**TOWN OF WINTER PARK  
PLANNING COMMISSION  
Tuesday, October 10, 2024 8:00 AM**

**TO** Planning Commission  
**FROM** James Shockey, Community Development Director  
**DATE** September 10, 2024  
**RE** Riverwalk at Winter Park, Lot 18 (PLN24-048)

Re: Planning Commission Action – Lot 18, Riverwalk Single-Family Structure Minor Site Plan  
(PLN24-048)

**TO** Planning Commission  
**FROM** James Shockey, AICP, Community Development Director  
**THROUGH** Brian P. Kelly, Senior Planner  
**DATE** October 8, 2024  
**RE** Minor Site Plan – 118 Apres Way - Lot 13 Riverwalk (PLN24-072)

**1 SITE PLAN**  
1" = 10'-0"

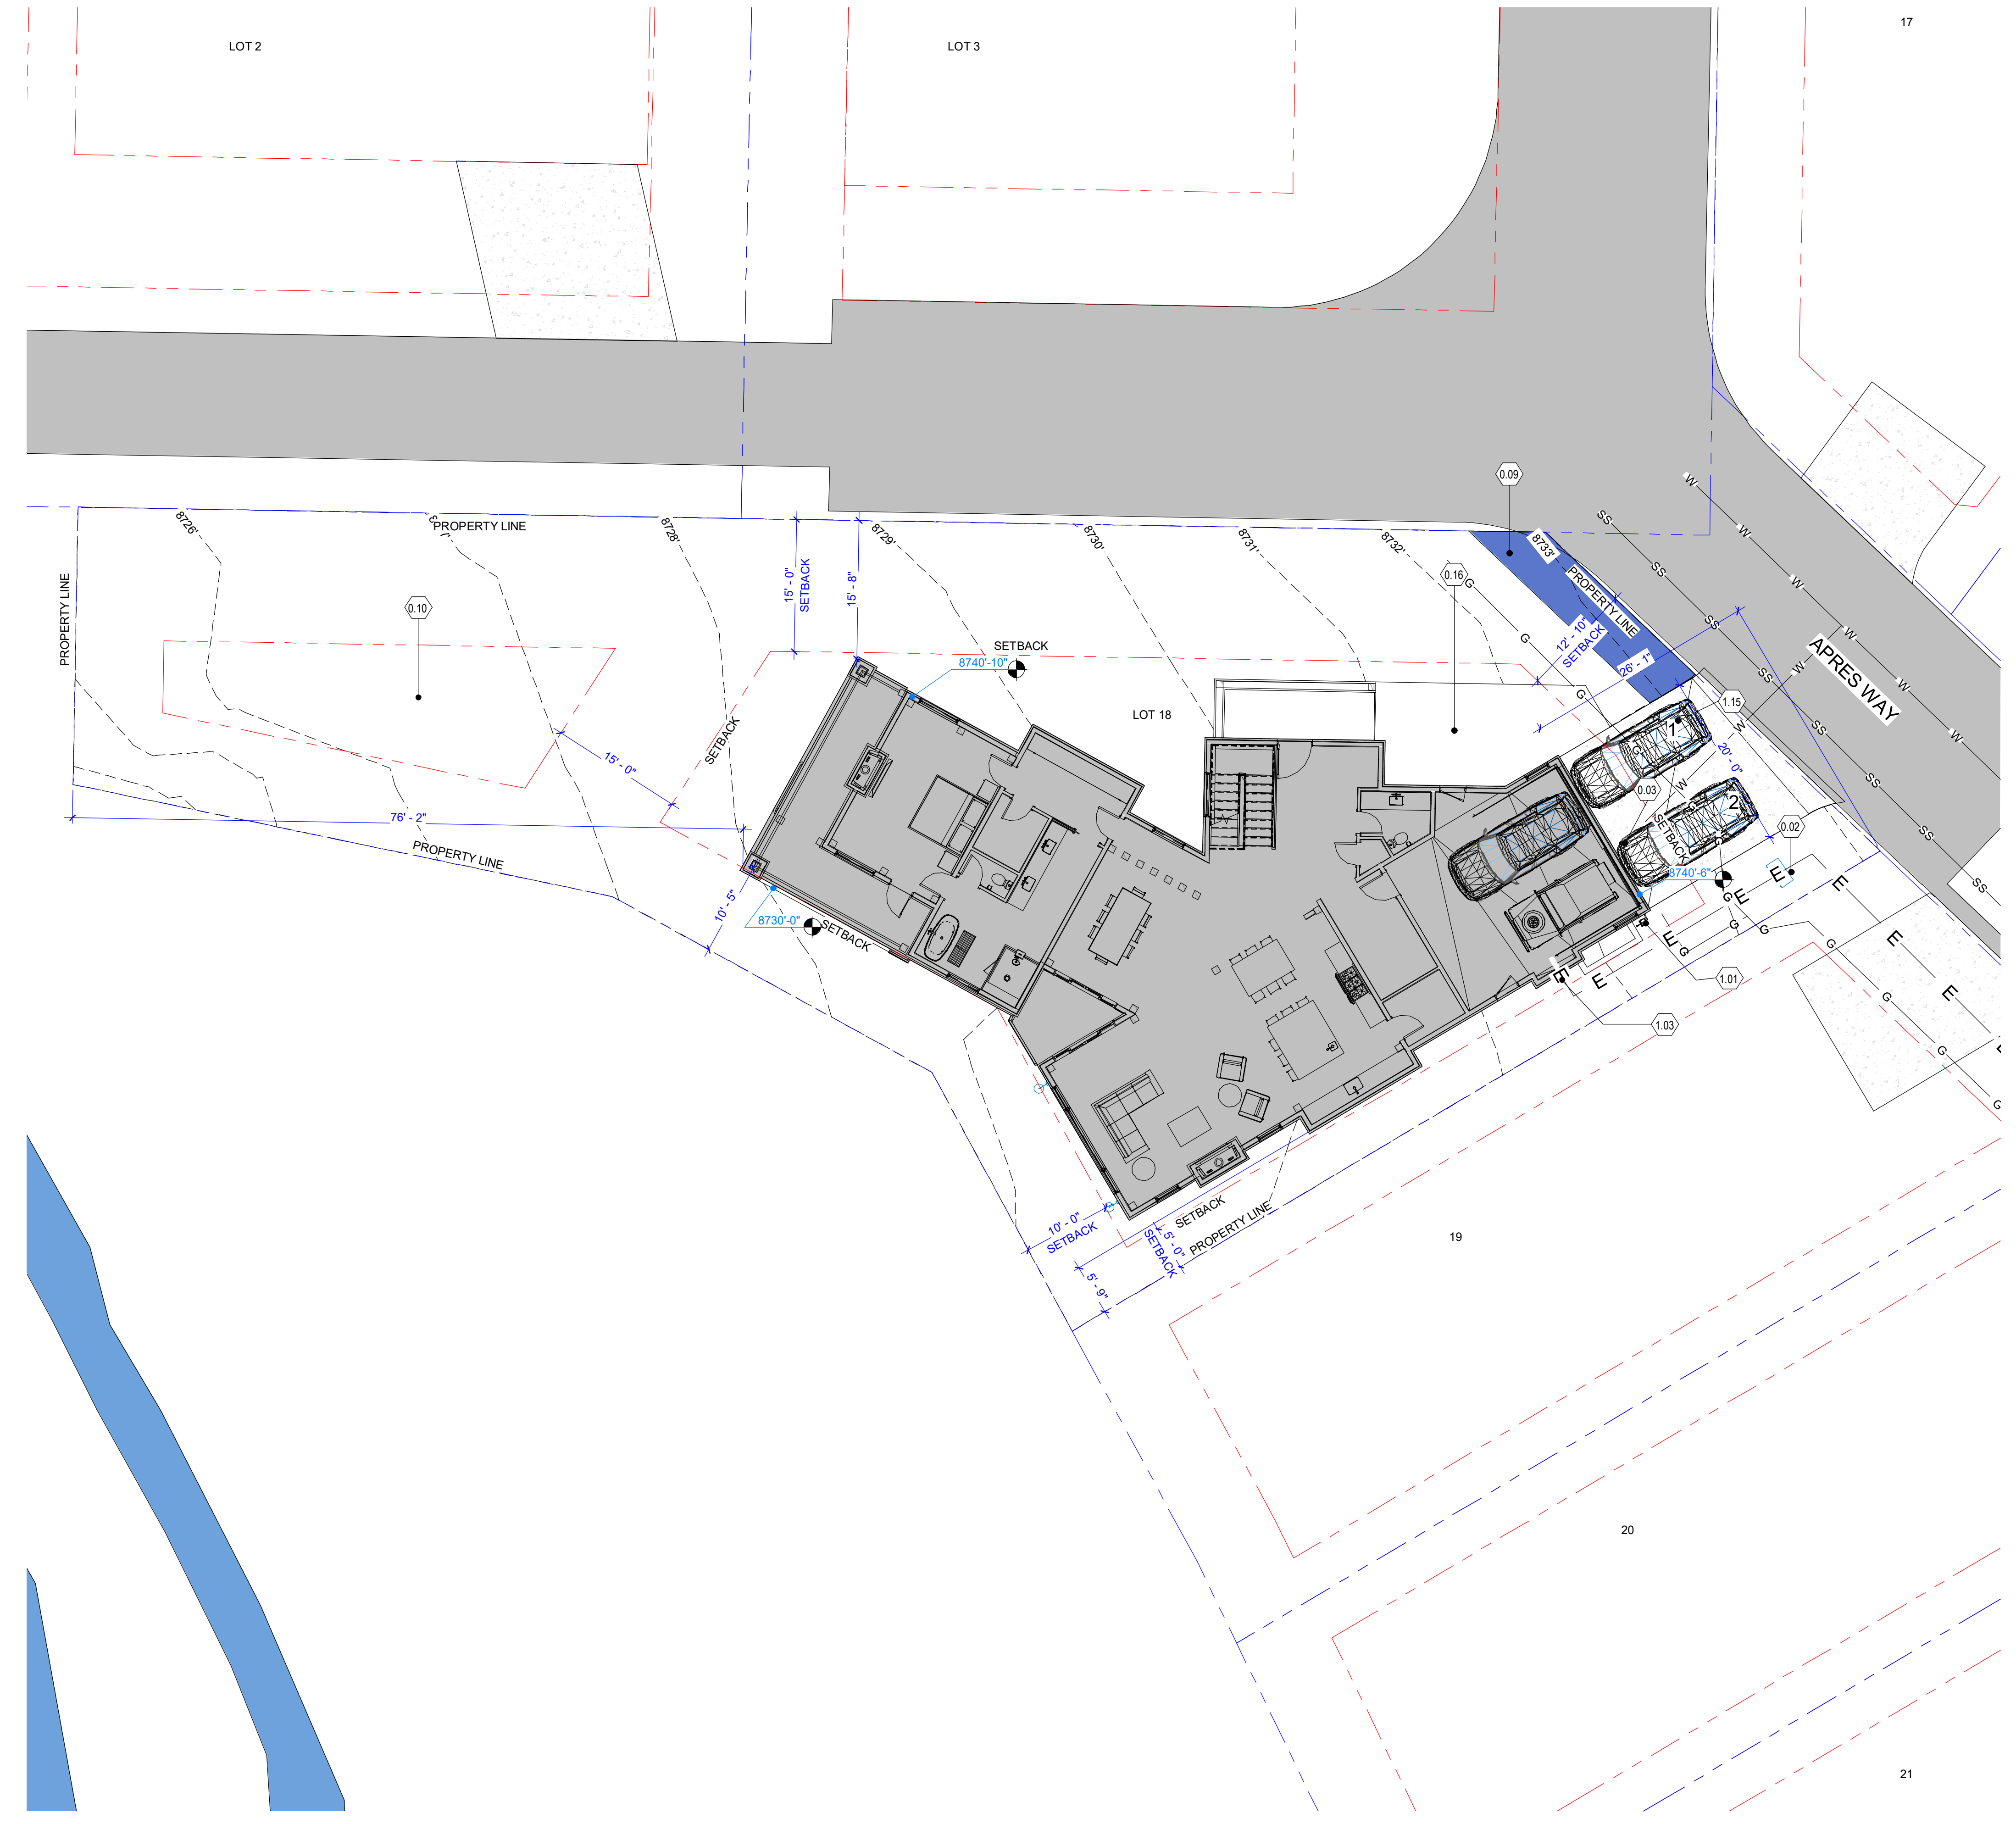
7. Limit of Disturbance line extends beyond the property line. Provide clarity in note that adjacent properties under separate ownership will not be disturbed permanently nor temporarily during all phases of construction. Specifically, show that the limit of disturbance does not include any of the adjacent jurisdictional wetlands.

10. Applicant shall provide confirmation that construction staging and parking are acceptable on adjacent property, owned by the Wheeler Trust.
11. Update the landscape plan to provide landscaping specific to Lot 18.

12. Update the site plan to provide a snow storage table that includes landscaped area, hardscape area, required snow storage, and provided snow storage specific to Lot 18.

13. Applicant shall redesign driveway to be compliant with the approved FDP.
14. Revise the site plan and site design to reduce total building coverage by approximately 4 percent (4%) to comply with maximum building coverage regulations.

Please refer to the newly added Landscape plan for Lot 18.

Please refer to the updated site plan as requested.

Please see the attached for the 24'-0" compliant driveway as requested. (site plan)

Please see the new plans and overhangs which are compliant to the 40 percent total coverage as required.
